Agenda
City of Springboro Planning Commission Meeting
Wednesday, July 13, 2022, 6:00 p.m.
Council Chambers, City Building, 320 West Central Avenue

Site Plan Review, western terminus Pinnacle Point Drive, medical office building for Mayfield Brain & Spine

This agenda item is based on an application filed by K4 Architecture, LLC, on behalf of Mayfield Brain & Spine Center, seeking preliminary review approval through the site plan review process to construct a 16,147-square foot medical office building on undeveloped land located at the western terminus of Pinnacle Point Drive. The subject property is located approximately 400 feet west of the intersection of Pinnacle Point Drive and West Tech Boulevard in The Ascent portion of the South Tech Business Park. The property currently has no address; property addresses are assigned by the Springboro Engineering Department later in the site development process. The site of the proposed medical office building is within the Montgomery County portion of Springboro.

PRELIMINARY SITE PLAN ASCENT - MAYFIELD

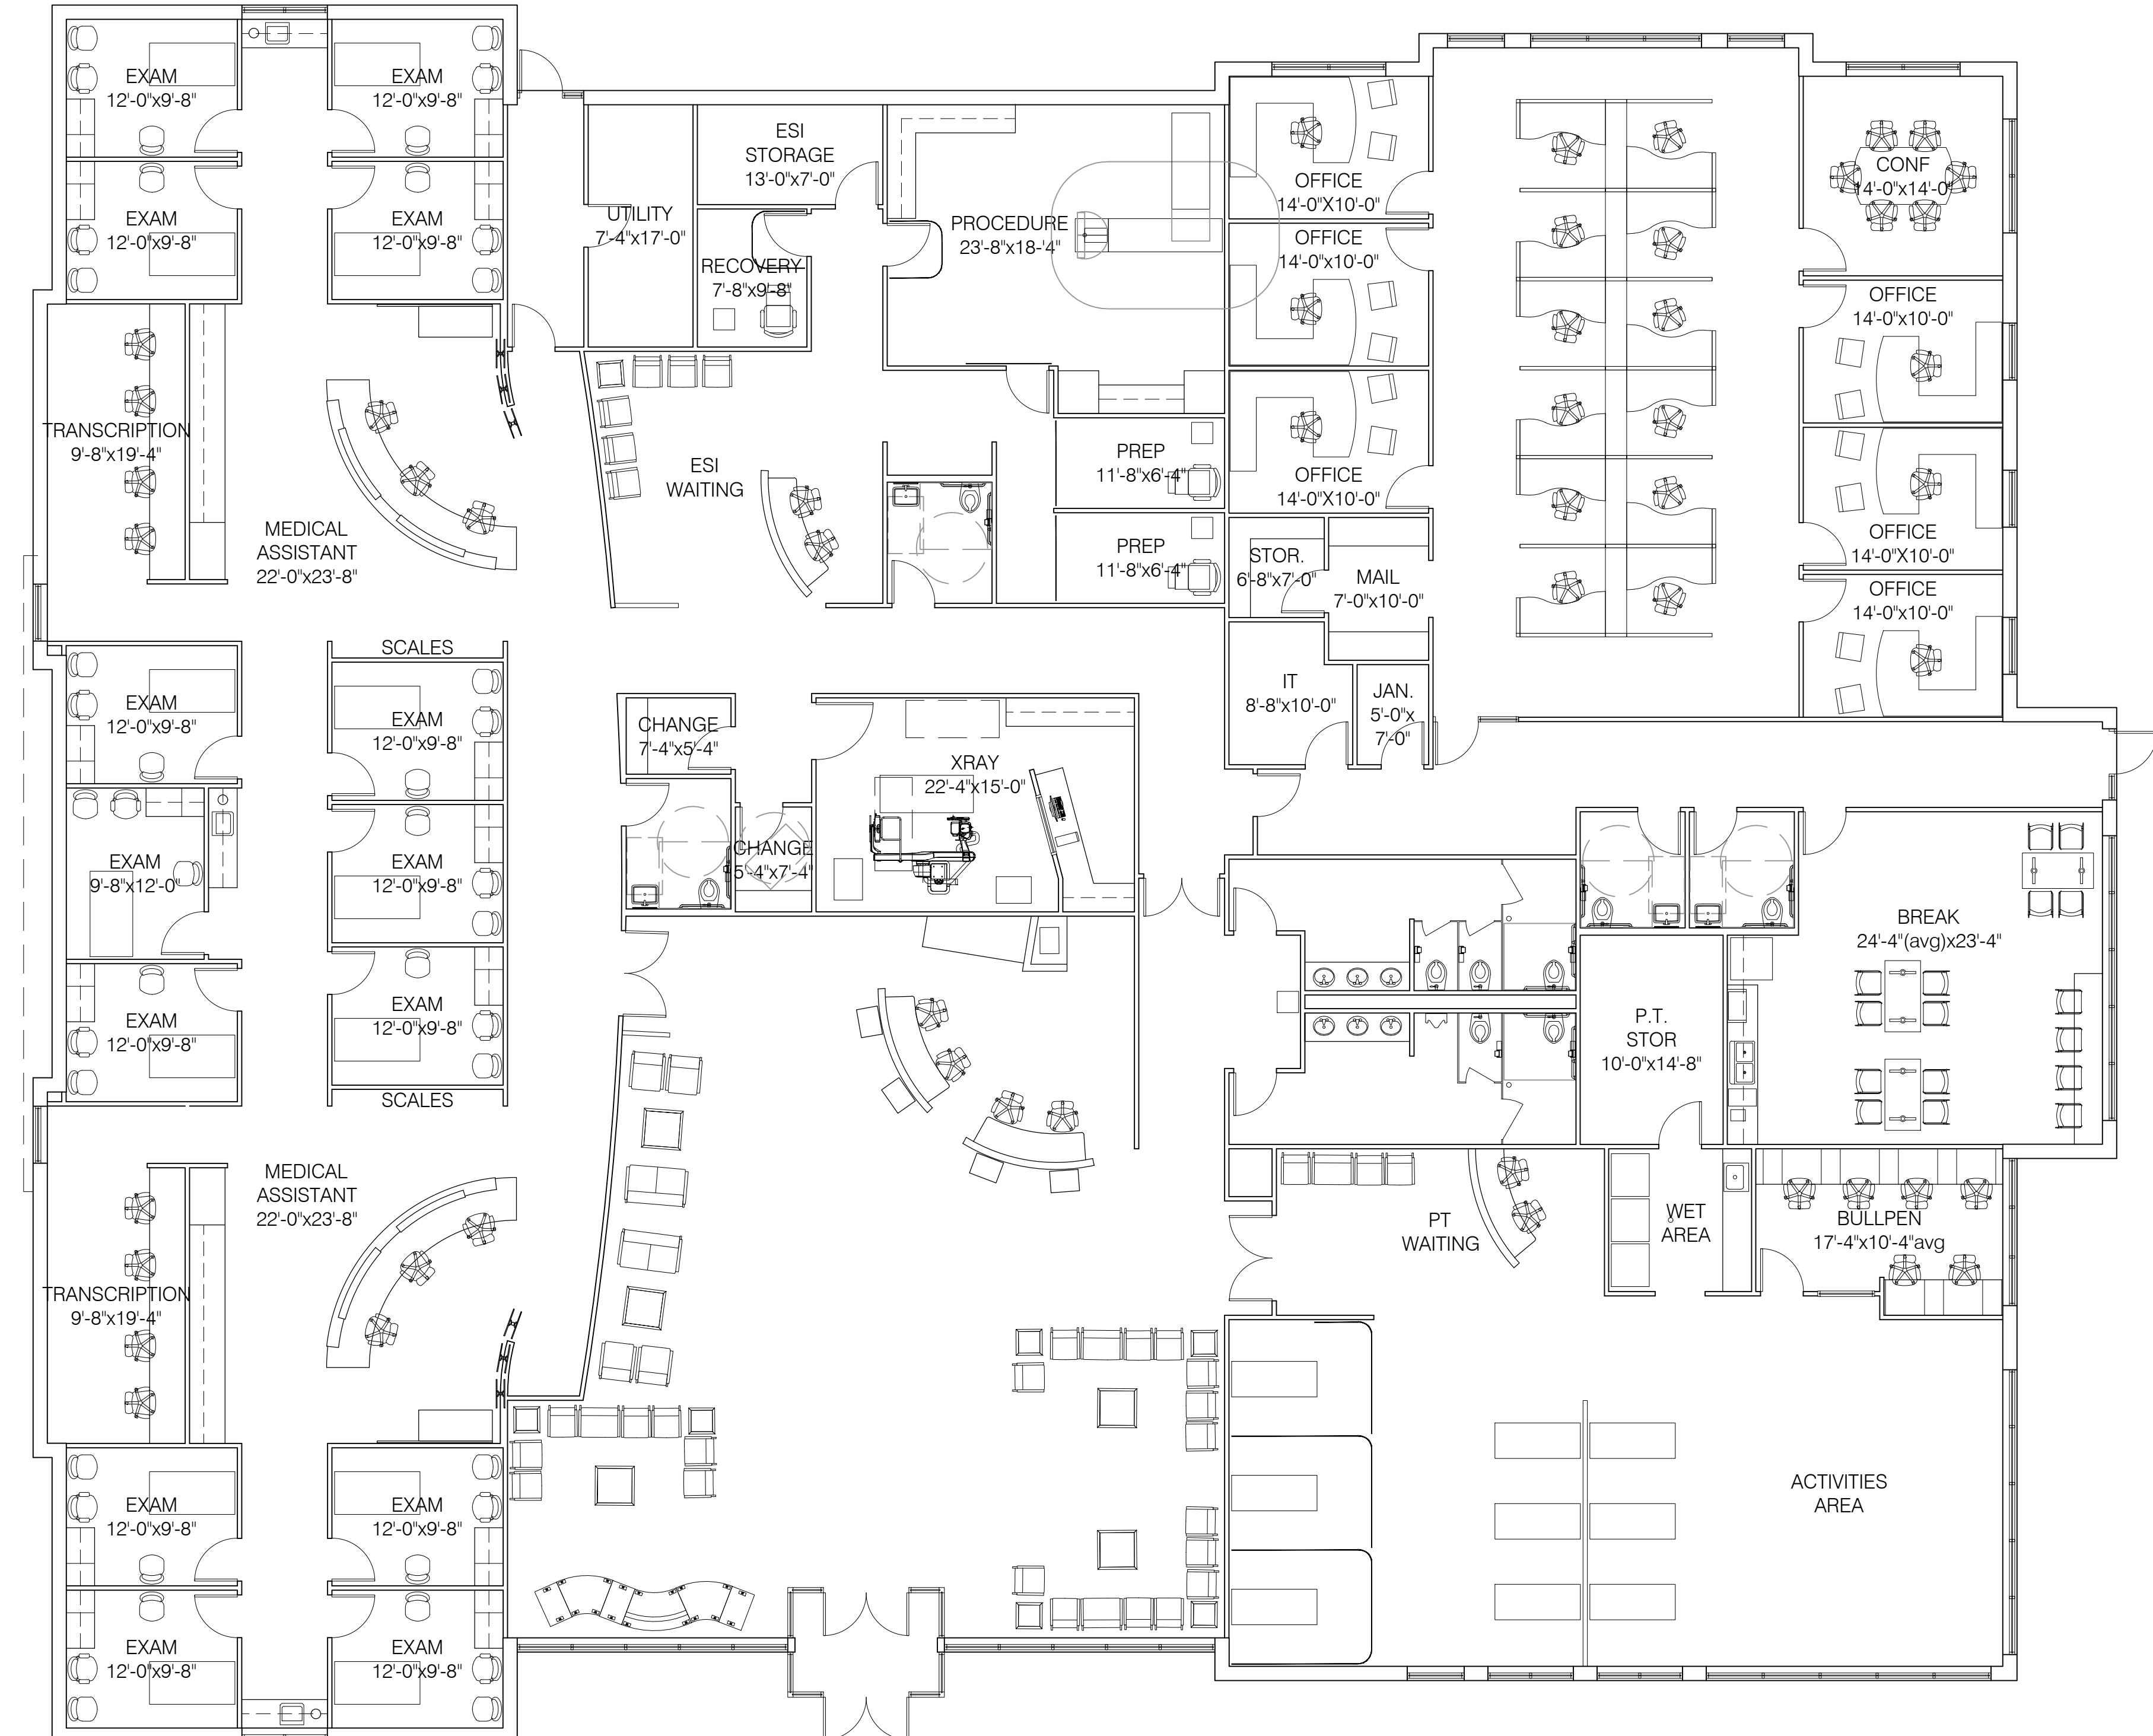
1. Indicate lot coverage for site at building out. Maximum lot coverage for the ADD-1 is 85%.
2. For final review and approval develop landscaping plan consistent with Section 1268(f)(4) including but not limited screening adjacent to road frontage on Pinnacle Point Drive and I-75,

buffers adjacent to other properties including the proposed ASC site, building foundation plantings, and parking lot plantings. Also indicate existing vegetation 4 inches DBH and larger to be preserved as Planning Commission may grant a reduction in plantings required as mentioned above.

3. Screen dumpster and mechanical systems consistent with Section 1268(f)(5) of ADD-1 requirements.
4. Signage to be consistent with Chapter 1281 of Planning & Zoning Code and Section 1268(f)(6) of ADD-1 requirements. Signage to be reviewed with Zoning Inspector separate from the site plan review process.

5. Indicate location for bicycle parking. Contact City staff for minimum requirements.
6. Indicate plans for sidewalks connecting to those to the remainder of South Tech/The Ascent.

7. For final review and approval develop lighting plan consistent with Chapter 1273, Exterior Lighting, of Planning & Zoning Code, and Section 1268(f)(10). Plan contents to include but not be limited to photometric analysis expressed in foot-candles, minimum to maximum (no greater than 10:1) and average to maximum ratios (no greater than 4:1), fixture details including proposed architectural lighting. No lighting to exceed maximum 3500° Kelvin color-temperature standard.

11. Fire Department connections for all sprinkled buildings shall be within 75 feet of a fire hydrant on the public water system. All fire department connections must have a 5" Storz connection with a 30 degree downturn and includes a cap attached by a cable or chain. Fire Department connections must be visible and unobstructed at all times.
